30 March 2022

Response to Peer Review of Hydrogeological Assessment and Groundwater Management Plan prepared by Dr Robert Banks

Map 03	Map
Lot 2 Gundy Rd, Scone, NSW	Site
Proposed Subdivision	Project
Groundwater Assessment Peer Review Response	Sub-Project
Charles David Pty Ltd	Client
30/03/2022	Date

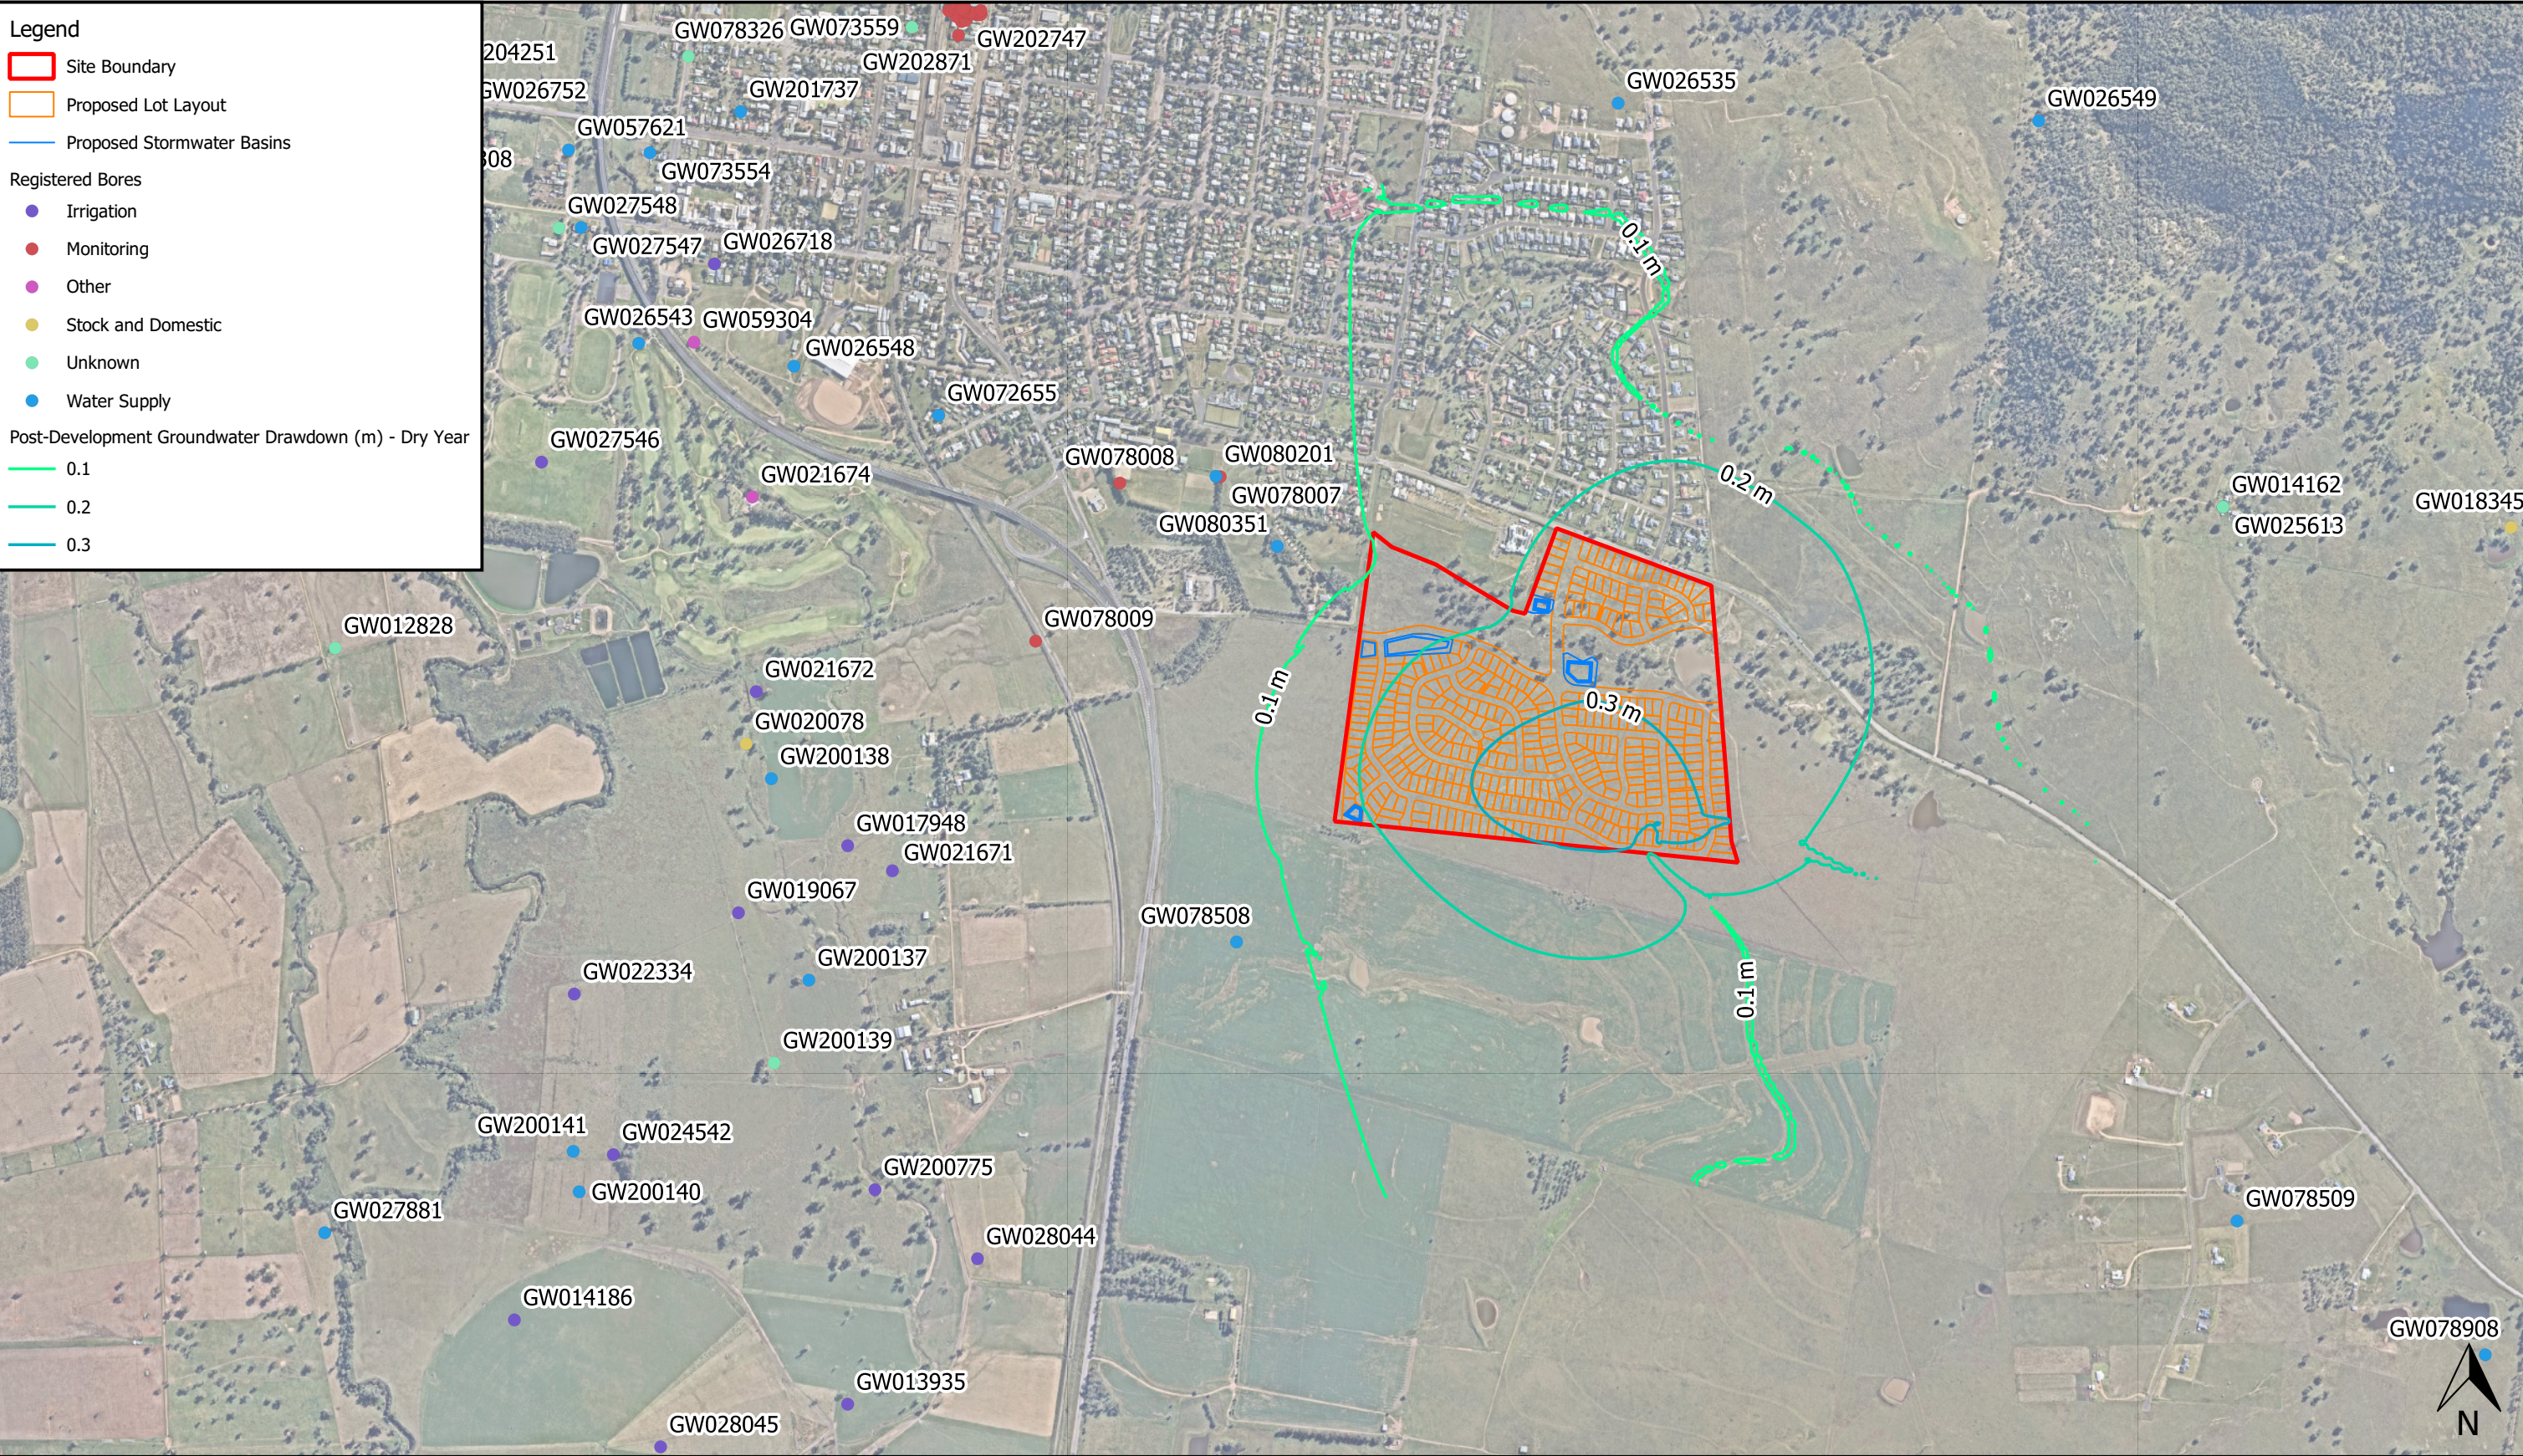
2. Impacts of the development on groundwater levels under average, dry and wet conditions were as follows:
 - a. Under long-term average conditions, groundwater levels in areas of saline soils downslope of the site and within the site are either marginally lowered or remain unchanged (refer to Map 6).
 - b. Under prolonged dry conditions, groundwater levels respond similarly to long-term average conditions, although the extent of lowering is reduced.
 - c. Under prolonged wet conditions, groundwater levels respond similarly to long-term average conditions however drawdown is increased beneath the development footprint.
3. Modelling indicates that the development will not lead to an increase in soil salinity conditions within the site or downslope. This is because groundwater levels will not be increased and there are therefore no anticipated changes to the capillary fringe.
